I-45 NHHIP Segment 3A Design Refinements & Structural Caps

PROPOSED CHANGES *

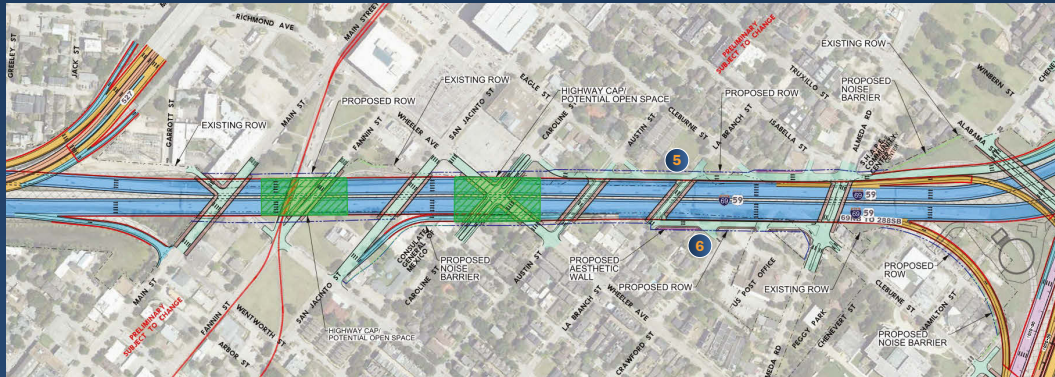
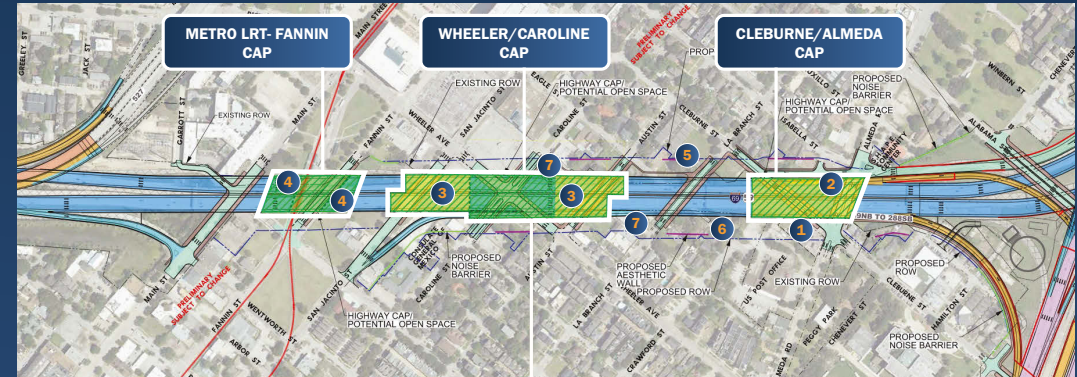
Extend Cleburne St. across I-69, preserving this important connection between Third Ward and Midtown.

Develop potential roadway cap extension opportunity between Almeda Rd. and Cleburne St.

Develop potential roadway cap extension opportunity, which would increase the cap area from Wheeler Ave. and Caroline St. to include San Jacinto and Austin streets.

Develop potential roadway cap extension opportunity which would increase the cap area to the west of the METRORail crossing, and to the east of the Fannin St. crossing.

Shorten I-69 southbound frontage road to end at Cleburne St.

Remove proposed I-69 northbound frontage road between La Branch St. and Almeda Rd.

- Requested by City of Houston and management districts
- Proposed frontage road creates adverse cross street intersections and does not enhance access and operations
- Enhanced bicycle/pedestrian opportunities in space where frontage road removed

Build specialized retaining walls due to high groundwater and excavation depth.
